21 December 2007

## **MEMORANDUM**

SUBJECT: Idaho National Laboratory Reactor Technology Complex Cold Waste Pond  
Wastewater Reuse Permit Application Review -- LA-000161-01 (Industrial  
Wastewater Facility)

Figure 1. Aquifer and perched wells at the site, including proposed monitoring wells.

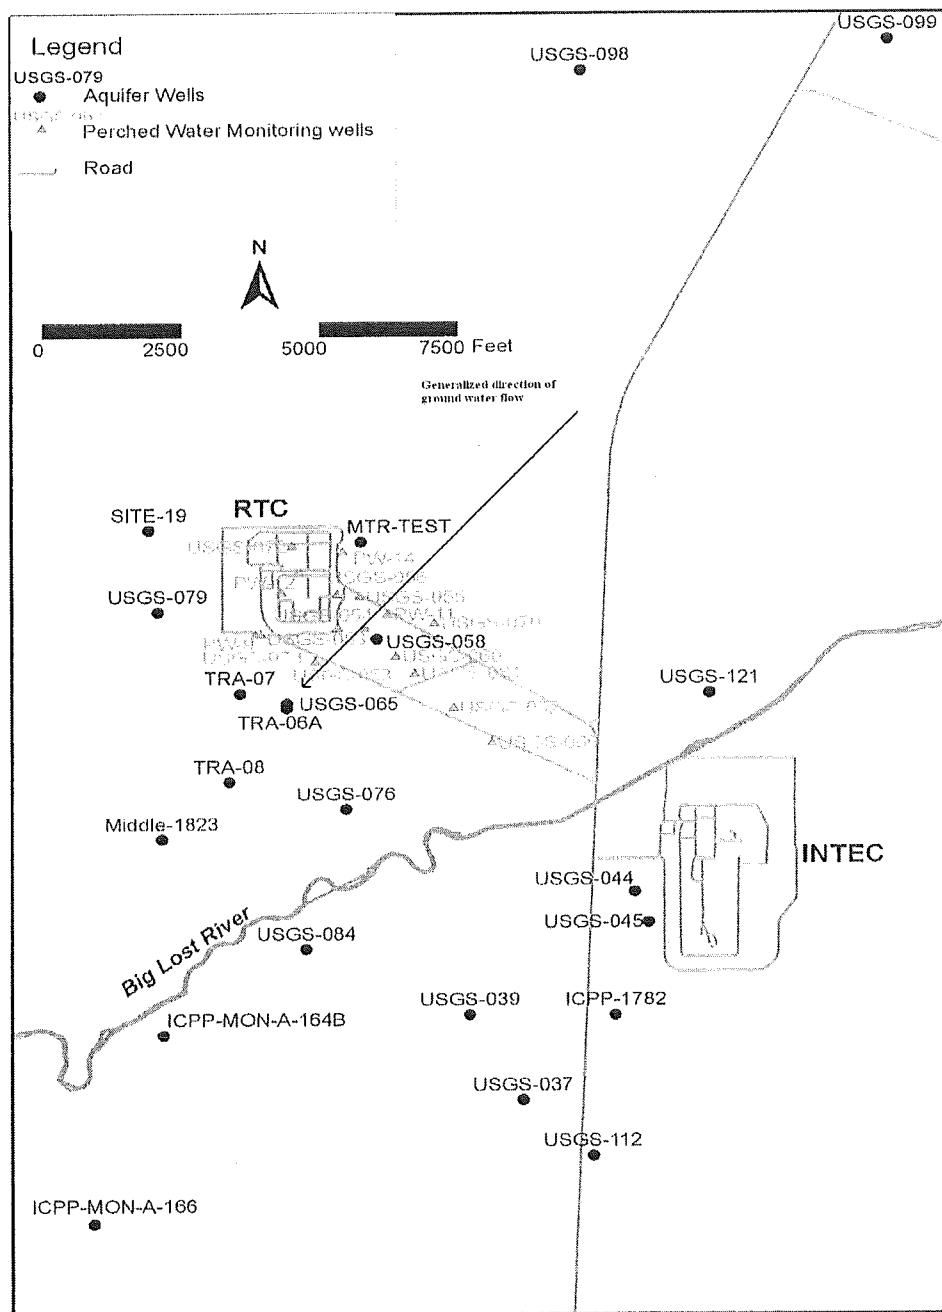
The facility is proposing the use of four (4) wells to determine compliance with the Idaho Ground Water Quality Rule at the CWP (TRA-03, TRA-07, USGS-65, and USGS-76). All four of the proposed wells are completed in the regional Snake River Plain Aquifer (SRPA), located approximately 480 feet below the site, rather than either the shallow or deep perched-water bodies that have formed as a result of infiltration from the various unlined ponds on the site. See Figure 1 for monitoring wells located at the site (Note: As TRA-03 is a production well, it is not included in this figure).

Given that aquifer flow is to the southwest, Well TRA-03 is virtually the only well in the area positioned to provide up/cross-gradient aquifer water quality data as it is located in the upper

northeast corner of the facility, up-gradient of not only the CWP but the other former percolation ponds in the immediate area. However, as it is also one of the RTC's production wells rather than a monitoring well, there is some question as to how reflective its water quality is of actual ambient up-gradient concentrations, in part due to the fact that the well pumps from a greater depth than the others. Wells USGS-065, TRA-07, and USGS-076 are proposed to monitor the aquifer down-gradient of the CWP. USGS-076 most likely occupies a more cross/down-gradient position, and its water quality more closely resembles that of TRA-03 than either USGS-065 or TRA-07. See Table 2 for averages of the laboratory results for these wells from 2000-2005 and comparison with their corresponding Ground Water Quality Standard (IDAPA 58.01.11.200).

It is recommended that the ground water monitoring be performed in Wells USGS-065, TRA-07, USGS-076, TRA-08, and Middle-1823 twice yearly (April and October). Ground water should be tested for water table depth, water table elevation, pH, total Kjeldahl nitrogen (TKN), nitrite-nitrogen, total suspended solids (TSS), total dissolved solids (TDS), aluminum, antimony, arsenic, barium, cadmium, chloride, chromium, cobalt, copper, fluoride, iron, manganese, mercury, selenium, silver, and sulfate.

**Figure 2. Deep perched water wells impacted by CWP**

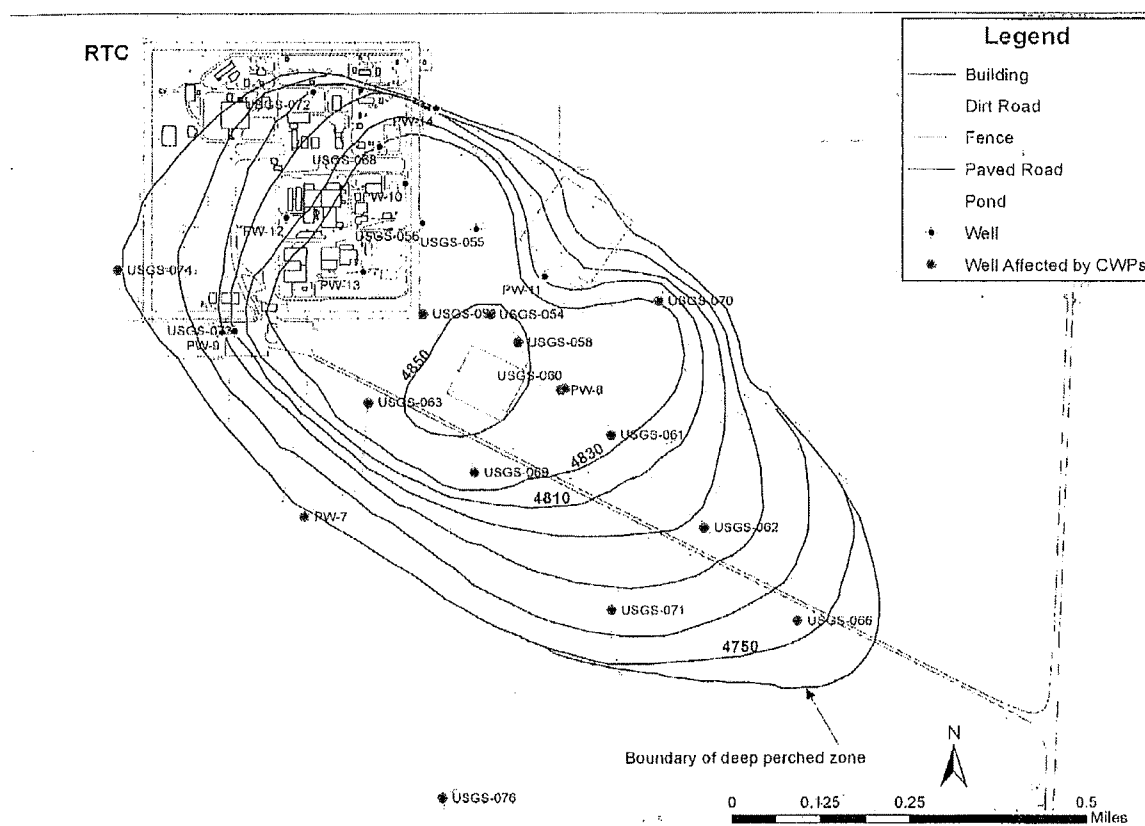
The shallow perched zone has eleven monitoring wells; however, as water levels in both zones tend to fluctuate in relation to hydraulic loading rates at the CWP, only two have remained consistently wet (CWP-1 and CWP-9). The deep zone has a network of 17 wells which are monitored for contaminants of concern, such as chromium and selected radionuclides under the CERCLA Record of Decision (ROD) for Operational Unit (OU) 2-13. See Figure 2 for perched wells on the site.

It is clear that the years of high sulfate loadings from the CWP have contributed to the elevated levels of the constituent in both the shallow and deep perched waters. The chromium contamination also appears to be more marked in these sets of monitoring wells because while only one well (USGS-066) shows levels above the ground water quality standard; several of the wells show levels of chromium above the pond's average and maximum effluent concentrations. Due to a number of factors, including the variable discharge to the CWP, contaminant levels in

the perched zone monitoring wells tend to fluctuate (DOE, 2005). While the vast majority of these contaminants can be attributed to historic sources that have since been remediated, their continued presence makes monitoring for compliance within the perched water zones impractical. Staff recommends that the proposed down-gradient wells USGS-65, TRA-07, and USGS-076, as well as TRA-08 and Middle-1823, be monitored for compliance twice per year (April and October) as a condition of the draft permit.

**Figure 3. Sulfate distribution in the Snake River Plain Aquifer in 1991 and 2004.**

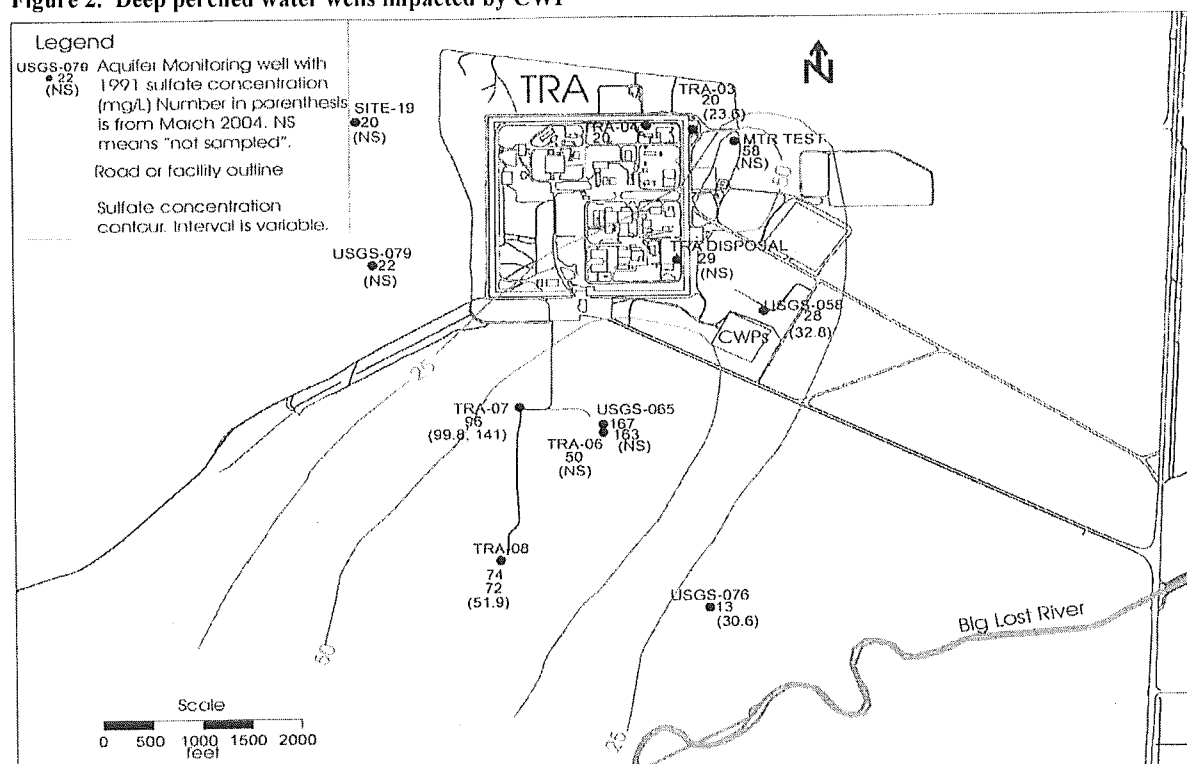
The facility has been monitoring the distribution of the sulfate plume for a number of years and a comparison of regional well results from 1991 to the present indicates that not only have sulfate levels remained fairly consistent, but that concentrations appear to dissipate fairly rapidly down-gradient of the facility. Regional aquifer well, TRA-08, located approximately 2000 feet down-gradient of wells TRA-07 and USGS-065 shows minimal CWP sulfate influence, as sulfate levels are on average 74 mg/l lower, and only 52 mg/l higher than up-gradient well concentrations (DOE, 2005). See Figure 3 for sulfate distribution in the regional aquifer wells in 1991 and 2004. Although it is evident that the CWP does have some impact with regards to sulfate concentrations on the various underground waters, especially in the perched waters, this impact does not appear to be overly significant or particularly far-reaching. It is recommended that both the wastewater effluent and the regional aquifer wells continue to be monitored for sulfate and the possibility of further action be considered should the sulfate concentration of the CWP effluent change or there are significant changes in the monitoring well results. For the full text of this condition please refer to Section G of the draft permit.
